1992 - 1993 Corvette: Service Bulletin: Noisy/Fraying Accessory Drive Belt

Subject: NOISY/FRAYING ACCESSORY DRIVE BELT (INST. SINGLE-SIDED BELT)

Model and Year: 1992-93 CORVETTE WITH 5.7L (LT1) ENGINE

Bulletin Number: 93-273-6A

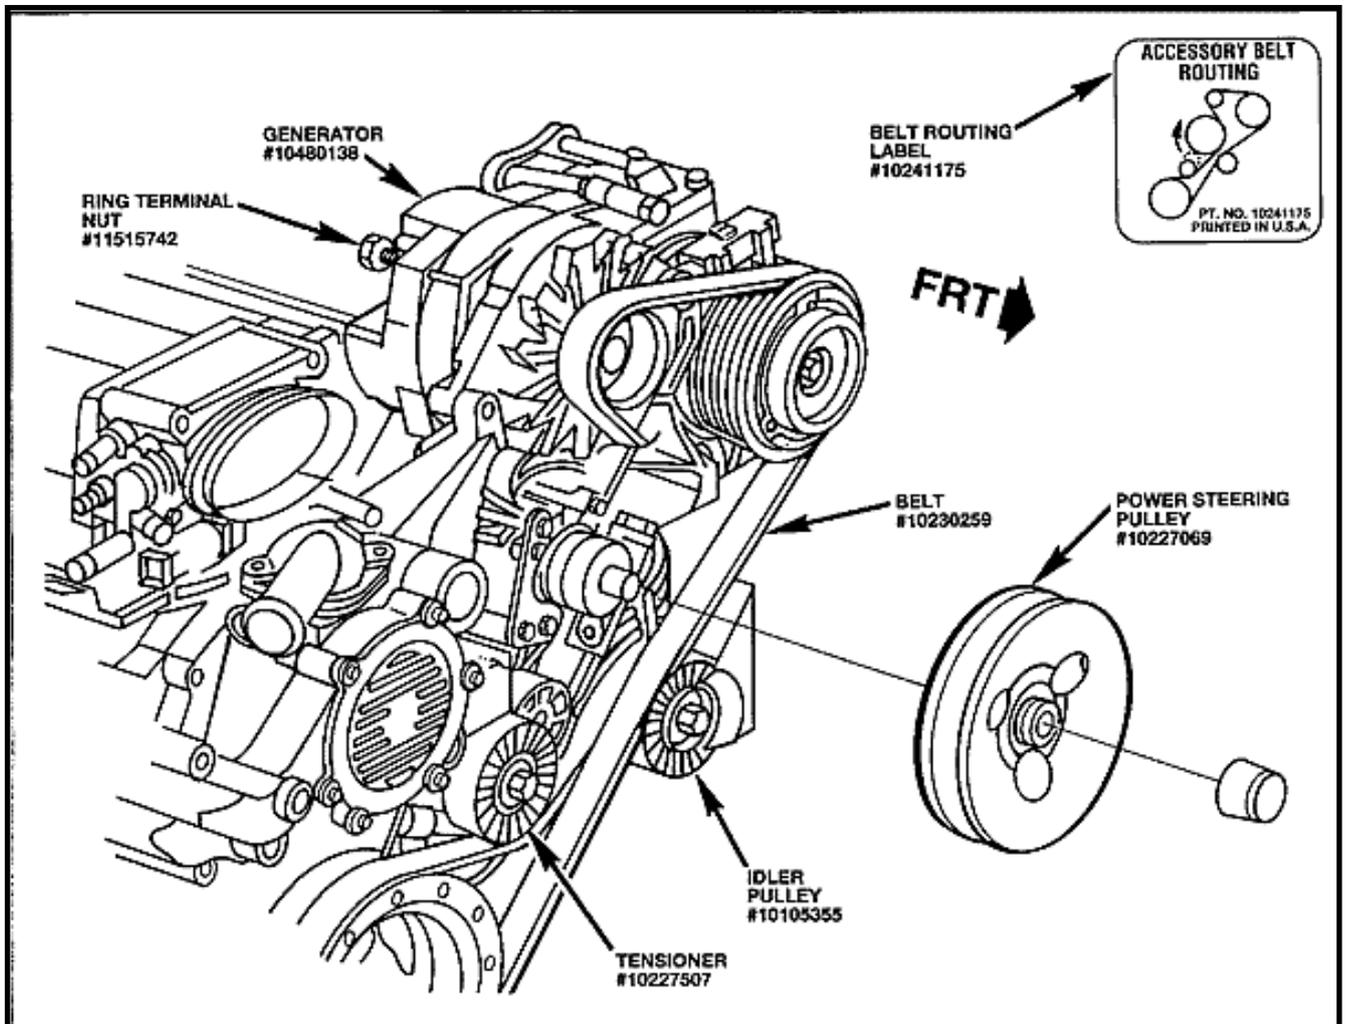
Some owners of 1992 and early 1993 model year Corvettes with 5.7L (LT1, VIN P) engines using the double-sided accessory drive belt may experience a noisy or fraying belt condition.

Inherent stresses and/or processing of the double-sided belt.

To correct this condition a change was made from the double-sided belt system to a new single-sided belt system. Starting the week of March 22,1993, VIN breakpoint #1G1YY23P4P5113150 Corvettes with LT1 engines were built with the new single-sided belt. To repair older units with the double-sided belt to a single-sided belt, the following parts must be installed:

NEW PART NO. DESCRIPTION

10230259 Belt

- 10227507 Tensioner
- 10227069 P/S Pulley
- 10105355 Idler Pulley
- 10463533 Generator
- 11502811 Generator Ring Terminal Nut #M8

NOTE: When replacing the new generator, the ring terminal on the wire harness will have to be opened up the 8.5mm to accommodate the larger stud on the back of the new generator.
